FORTISBC INC. 2017 COST OF SERVICE ANALYSIS & RATE DESIGN	EXHIBIT A-5
--	--------------------

**Re: FortisBC Inc. – 2017 Cost of Service Analysis and Rate Design Application – Project No. 1598939 –
Regulatory Timetable and Public Notice**

FortisBC Inc.
2017 Cost of Service Analysis and Rate Design Application

INFORMATION REQUEST NO. 1 TO FORTISBC INC.

Figure 7-10: Residential Rate Structures for Various Canadian Natural Gas Distributors¹¹³

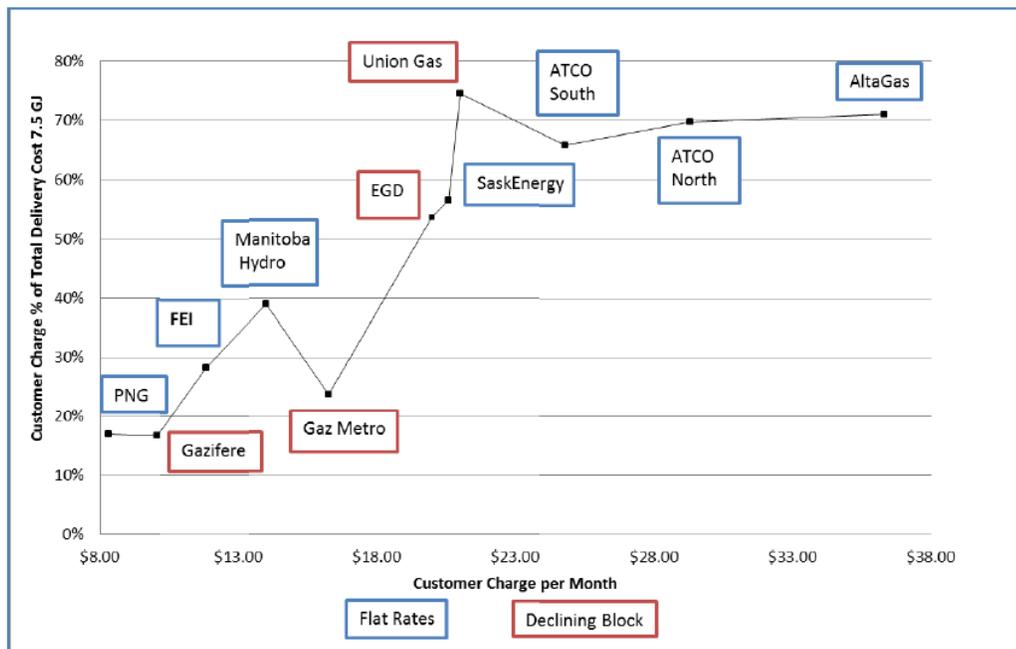
41.1 Please provide a similar graph for the utilities included in the FBC 2017 COSA review, which are listed on page 11 of the 2017 COSA Report. Please use the customer charge as a percent of customer-related unit cost on the y-axis and the customer charge in dollar per month on the x-axis.

The 2017 COSA Report includes Figure 1 on page 36:

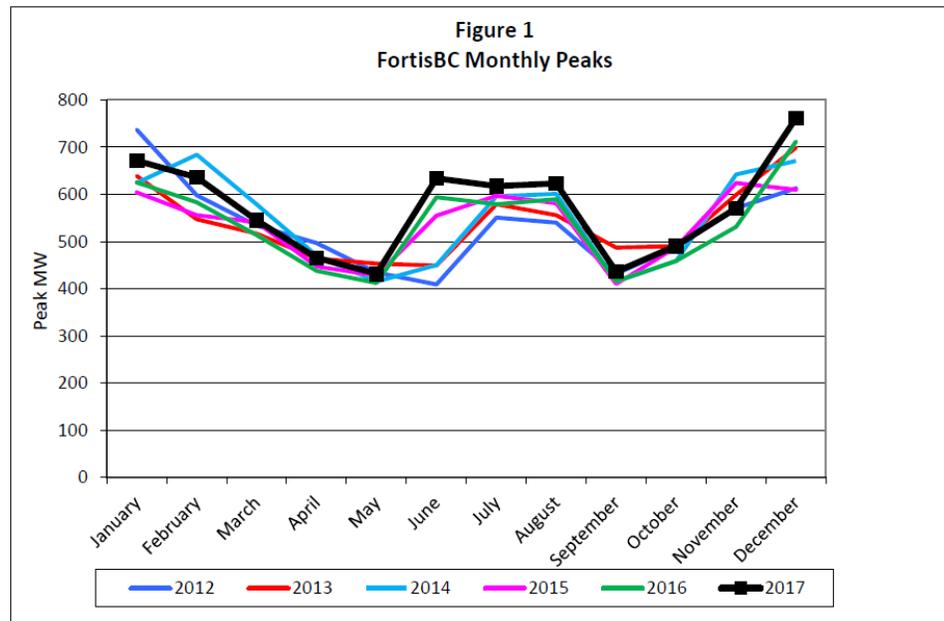
- 80.1 FBC refers to the “analysis” or the “load analysis” throughout this section of the Application but only provides the results of such analysis. Please provide the 5-year load analysis, including any graphs showing daily loads during the on-peak, mid-peak and off-peak periods, for each of the three pricing seasons and for each customer class.

- 80.3.1 Based on Figure 1 above, please confirm, or explain otherwise, that the summer peak is trending toward a three-month peak (2015 to 2017) from a two-month peak (2012 to 2014).
